76 Muswell Road, London, N10 2BE
Planning application ref: HGY/2026/0584

We write on behalf the householder - Mr Paul Berkovi - in respect of the application for 76 Muswell Road, which seeks planning permission for *"Erection of a single storey rear extension"*.

Mr Berkovi has instructed Bell Cornwell as specialist town planning consultants, to review the proposals and the comments raised by the case officer. This letter is provided in response to the matters raised.

Fig 4.1- Proposed Block Plan

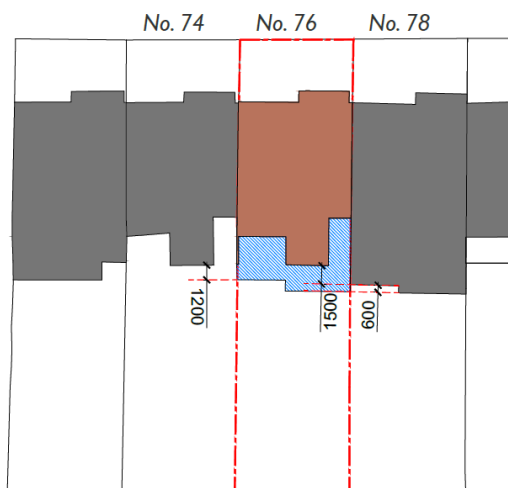
3. Whilst there are examples of contemporary designed rear extensions on this road, an alternative form of rear extension which allows the rear outrigger to remain appreciable should be considered, due to concern that the existing proposals cause some harm to the significance of the Muswell Hill Conservation resulting from the loss of the nineteenth century form of the building. In a subsequent email issued on 24 June 2026, the case officer confirmed a flat roof to be a more appropriate roof form than a pitched roof and the use of yellow stock brick is supported.

Mindful of the immediate context provided by the rear extension to no.78, the design approach has been to match this extension’s form and general appearance, and provide a footprint that also matches the neighbouring extension (as shown below) –in turn providing more consistency of appearance to the rear elevations of these properties.

The proposed extension seeks to maintain the floor to ceiling height of the host building, with a flat roof proposed to minimise massing and ensure the extension is of an appropriate height. Whilst the appearance of the outrigger will be lost at ground floor level, the existing outrigger (common to all the other outriggers along the terrace) has already been considerably altered. The outrigger will remain as a clearly distinguishable architectural feature at first and second floor levels (albeit it is clearly a modern extension at 2nd floor level rather than a nineteenth century feature). This is important to note, as the

"45 Degree Horizontal Plane test"

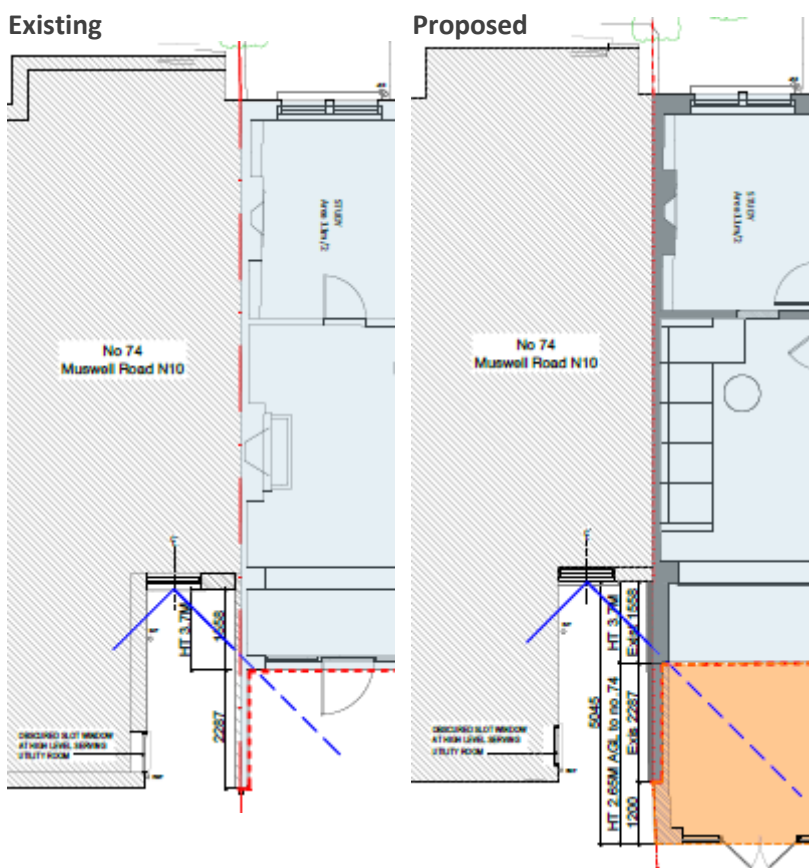
2. The proposed extension would extend to 5m in depth and would be built right up to the boundary shared with No. 74 which does not have an existing rear extension along this boundary, the proposals could result in adverse impacts on the residential amenities of No. 74 in terms of loss daylight/sunlight and increased sense of enclosure. It is suggested that a Daylight and Sunlight Assessment is submitted to show that the impact is acceptable, or changes may need to be made to the proposed scheme.

undertaken for this window, and instead focuses on the the nearest window to the rear elevation to No.74 (which faces into the lightwell) - as shown on the attached drawing (ref: 1076 -101/A) and the extracts below.

As can be seen in the Horizontal Plane Test (below), the 45-degree line from the centre of the nearest adjoining ground floor window to no.74 is already breached by the side-wall to the existing rear extension to the property. Whilst the proposed extension will introduce additional massing extending 1.2m beyond the existing projecting side-wall to No.76, within the 45 degree plane this additional massing will be some 4m beyond the adjoining window and thus will only be likely to result in a limited sense of enclosure as a consequence.

It is also a significant material consideration that, in approving the rear extension to no.78, it was noted by officers that on the side facing no. 76, the extension would extend by 1.5m beyond the existing outrigger. Officers considered (at para 6.11 of the officer's report) that this limited depth at 1.5m would not cause any further impact with regards to loss of daylight. In respect of these extension proposals for no. 76, the floorplate is proposed to be inset adjoining no.74, so as to extend only 1.2m beyond the existing outrigger to no.74.
